**South Port Industrial Park**  
**Master Development Plan**

**City of San Antonio**  
**Development Services Department**  
**Master Development Plan**  
**APPLICATION**

Re: Southport Industrial Park Subdivision

MDP # 841

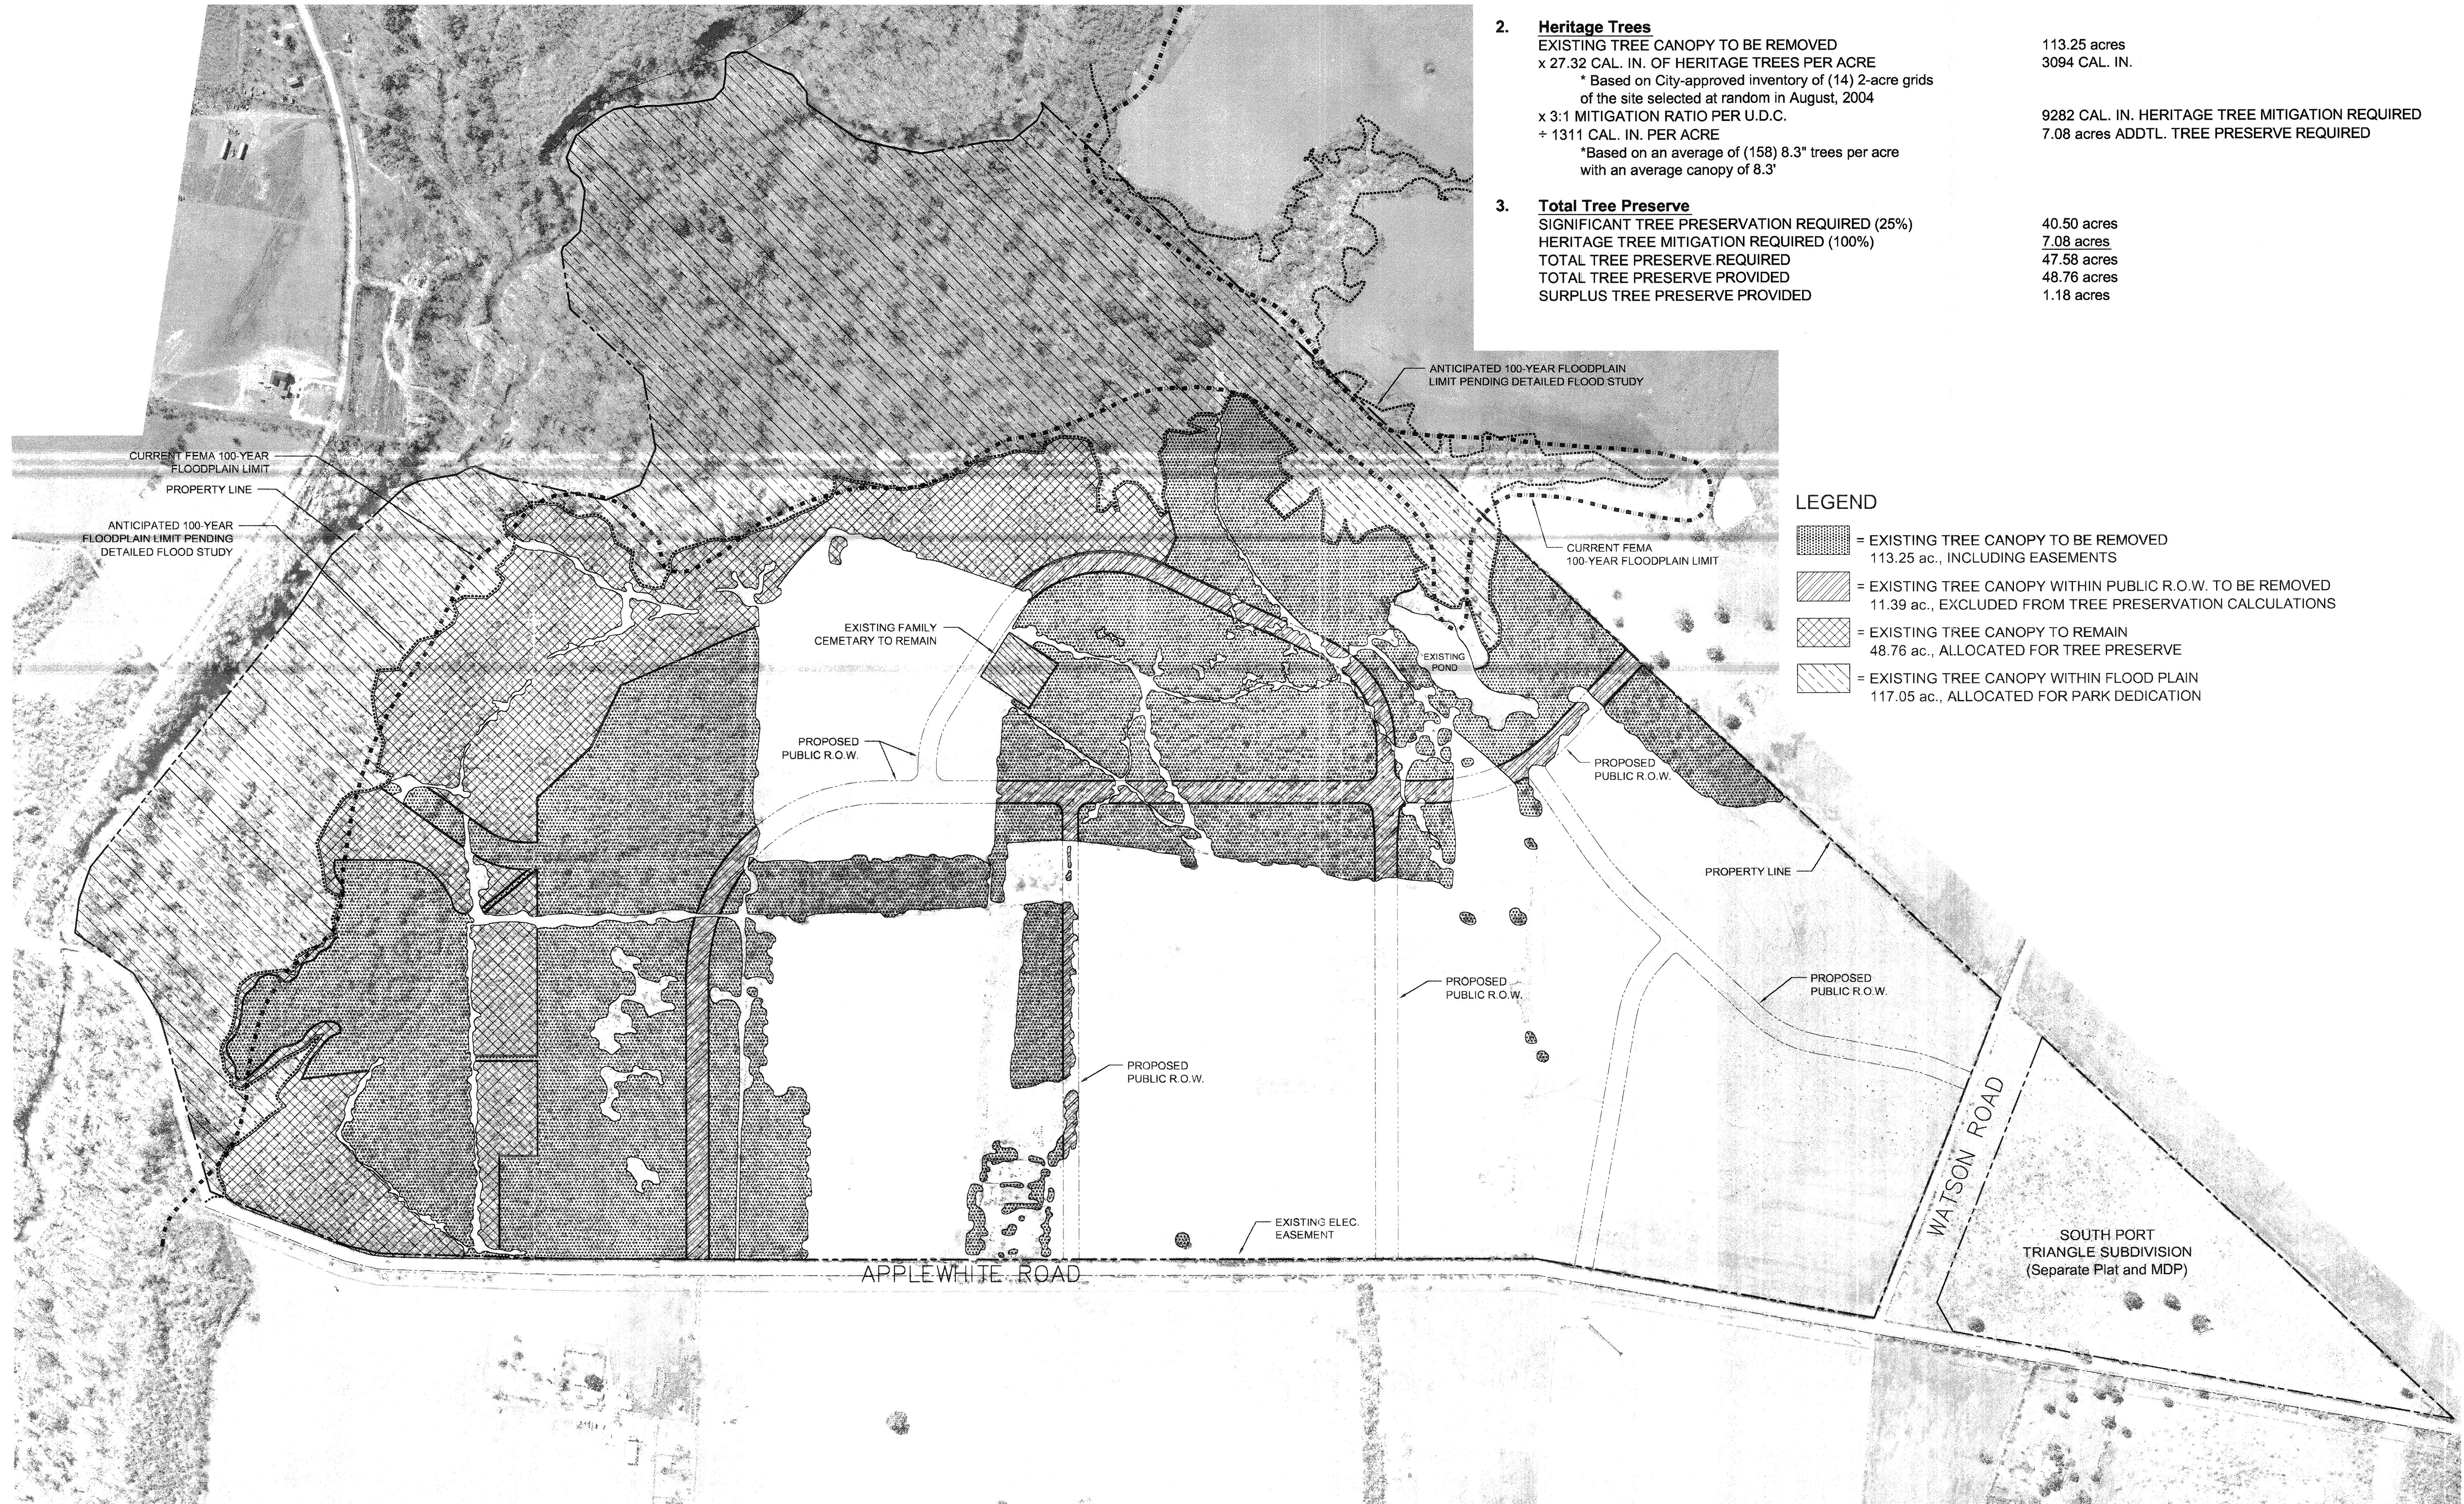
PLEASE ADD A 'GENERAL NOTE' TO PLANS STATING THAT  
SIDEWALKS WILL BE INSTALLED IN THE PUBLIC RIGHT-OF-WAY  
PER UDC ARTICLE 5, DIVISION 2: 35-506(q.)

Also include a cross-section profile view of the street showing width  
and placement of sidewalk.

**The Master Development Plan / Flex District Plan, should be submitted on One (1) Sheet and make the Title the same as shown.**

**Show contours, show the Parking and Area Calculation Table, Open Space Table, Typical Street Sections, TxDot Notes ,**

**Show the street layout along with buildings and parking spaces(Site Plan), Phasing, Land use/Floor area calculations, Etc.**

**Provide centerline dimensions on Applewhite Rd. and Watson Rd.**

**Place Note on plan: "The floodplain is to be platted with units - 1, 2, 3 and 4 proportionally".**

2. If no hydraulics study is being done for the FEMA floodplain within the proposed development, need to provide note, and signature of the Owner and Engineer on the MDP Plan. Here is the note as follow:

"The Floodplain limits on this Master Development Plan are estimated and subject to change. Approval of subdivision plats associated with this Master Development Plan is subject to the review and approval of a Storm Water Management Plan in accordance with Appendix B, Section 35-B119 of the City of San Antonio Unified Development Code."

The foodplain levels in the Master Development Plan are estimated and subject to change. Approval of subdivision plans associated with this Master Development Plan is subject to the review and approval of a Drainage Water Management Plan in accordance with Appendix B, Section 35-B11.8 of the City of San Antonio Unified Development Code.
